**INDIANA OFFICE OF UTILITY CONSUMER COUNSELOR  
COMMENTS ON NORTHERN INDIANA PUBLIC SERVICE COMPANY'S  
2024 INTEGRATED RESOURCE PLAN**

**APRIL 17, 2025**

Figure OUCC-1 35-year Life LCOE

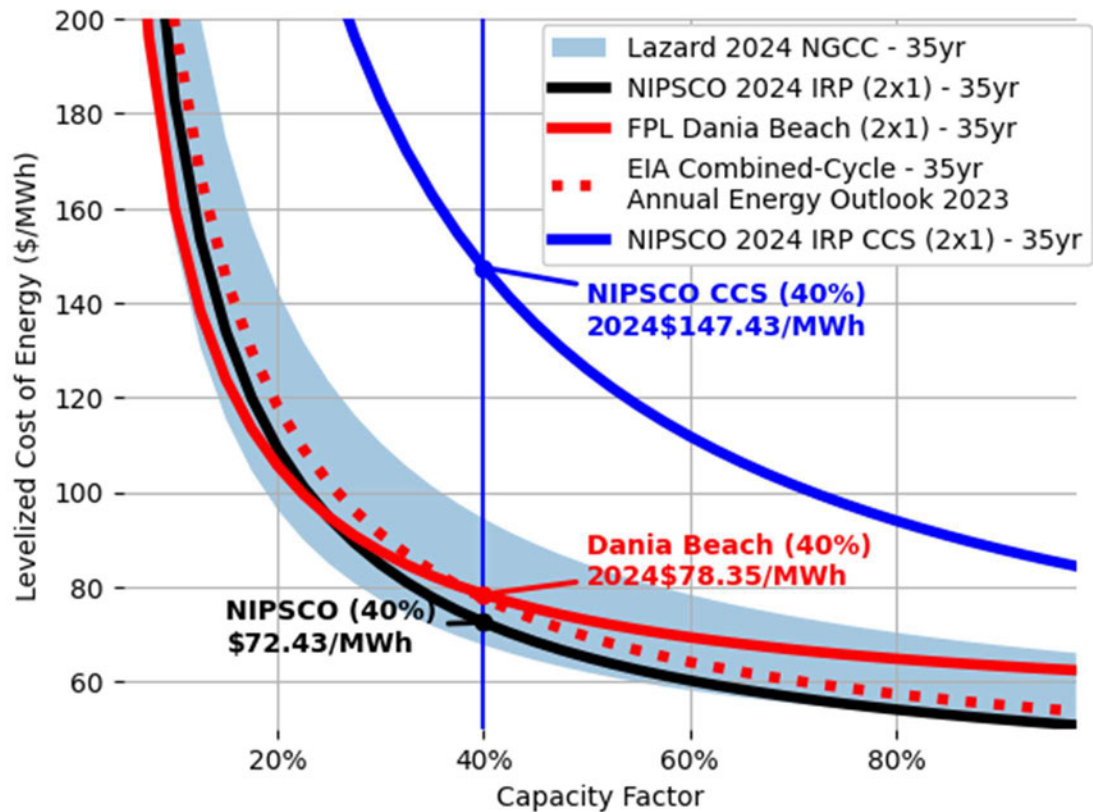
In Figure OUCC-1 below, the solid black line represents NIPSCO's LCOE based on the capacity factor or expected CC usage. As the figure reveals, the more a generator is used, the more cost the utility recovers, and the lower the LCOE. It also shows NIPSCO's IRP CC LCOE to be underestimated when compared to EIA and Lazard benchmarks and demonstrates the extreme cost impact of adding CCS, the blue line.

A CC is best used as a baseload generator. The 40% capacity factor identified in Figure OUCC-1 is, however, the maximum annual capacity for new base load CC turbines to comply with the EPA's 2032 requirement in the Clean Air Act Section 111 (b) Rule, unless retrofitted with 90% carbon capture.<sup>10</sup>

For comparison purposes, the OUCC utilized a 35-year adjustment to the LCOE because Duke Energy uses an expected 35-year life for two 738 MW 1x1 CCs in its proposed Cayuga project (CPCN pending under Cause No. 46193). However, as the cost of Duke's proposed CC has not been approved, the OUCC uses costs from the Florida Power & Light ("FPL") Dania Beach Clean Energy Center ("DBEC") CC that began construction in 2020. DBEC went online in 2022 with the same equipment and has reported two full years of power data. It must be noted that DBEC is the most realistic benchmark available, as the project replaced on-site retiring CCs and, therefore, had most infrastructure already in place. This will not be the case for NIPSCO. Nevertheless, the OUCC contrasts the cost per energy of FPL's DBEC utilizing fuel efficiency data and approved OCC<sup>11</sup> and adapting all other cost assumptions used by NIPSCO to calculate a comparable LCOE for the FPL DBEC (reference the thick red line in Figure OUCC-1).

A range of OCC expenditure (2024 nominal dollars per kW) should be used, anywhere between \$1,200/kW (e.g., DBEC at \$1,205/kW and NIPSCO at \$1,225/kW) and \$1,700/kW, the highest National Renewable Energy Laboratory (NREL) Annual Technology Baseline cost.<sup>12</sup> The Energy Information Agency (EIA) LCOE benchmark lies nearly at mid-range at \$1,507/kW when inflation-adjusted to 2024.<sup>13</sup> Lazard's range assumes \$850/kW and \$1,300/kW; however, its financial returns are assumed to be much higher, resulting in a higher overall present value. By NIPSCO's financial assumptions, Lazard's upper OCC lands near \$2,000/kW. NIPSCO should utilize and test a wider estimate range of OCC given the uncertainty of forecasting.

Although NIPSCO's costs begin to converge with the EIA's estimates at higher capacity factors, NIPSCO's heat rate (Btu/kWh) is likely unachievable. The EIA reports 6,431 Btu/kWh. With

The OUCC recommends a wider range of resource costs be used in each scenario to evaluate the best portfolio, placing greater emphasis on recent cost benchmarks, as that will more accurately predict the amount ratepayers will pay and, therefore, more accurately predict the affordability of the selection.

Figure OUCC-2 35-Year Life LCOE vs Refueling

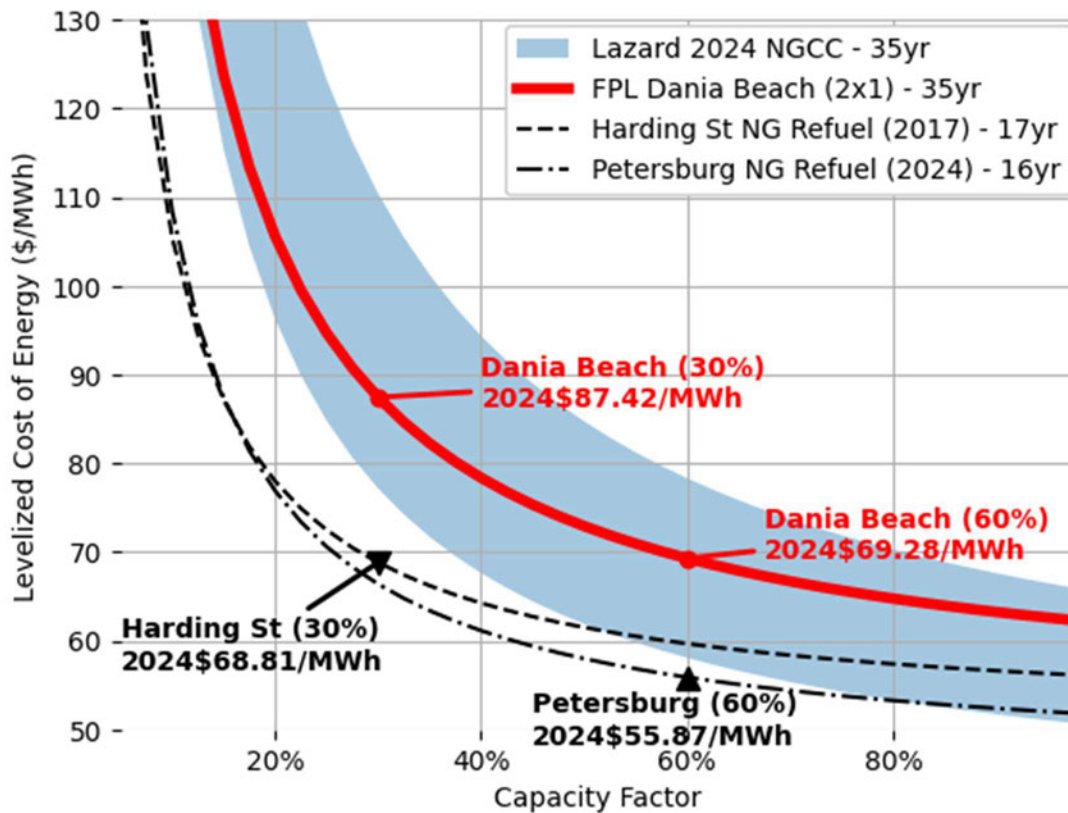
The OUCC also evaluated the LCOEs of conversion costs of AES Indiana’s Harding Street Station (\$106.88 million in IPL’s 2016 Semi-Annual Update<sup>17</sup> for Units 5 & 6 in Cause No. 44339 and Unit 7 in Cause No. 44540) and the Petersburg Generating Station conversion (\$293.3 million approved in Cause No. 46022<sup>18</sup>). The levelized cost of conversion provides a benchmark for the Michigan City LCOE whose life could be extended by conversion to natural gas. The OUCC calculated an average annual capacity factor over 6 years of approximately 30% for Harding Street and assumed continuation of approximately 60% for Petersburg once converted<sup>19</sup> (the LCOEs marked in Figure OUCC-2 by downward- and upward-pointing arrows, respectively). The OUCC

Figure OUCC-2 demonstrates NIPSCO should have evaluated the option of converting its Michigan City facility to natural gas rather than retiring it altogether. However, this LCOE comparison does not directly include the ease of construction or other benefits NIPSCO could obtain from converting Michigan City, which can be achieved in a shorter timeframe than a completely new construction and full retirement of Michigan City. A conversion or delay in retirement of the existing coal-fired units could address the shortfall due to NIPSCO retiring coal-fired supply and may offset market prices from PPAs. NIPSCO failed to include analysis or discussion of Michigan City conversion as a viable option.
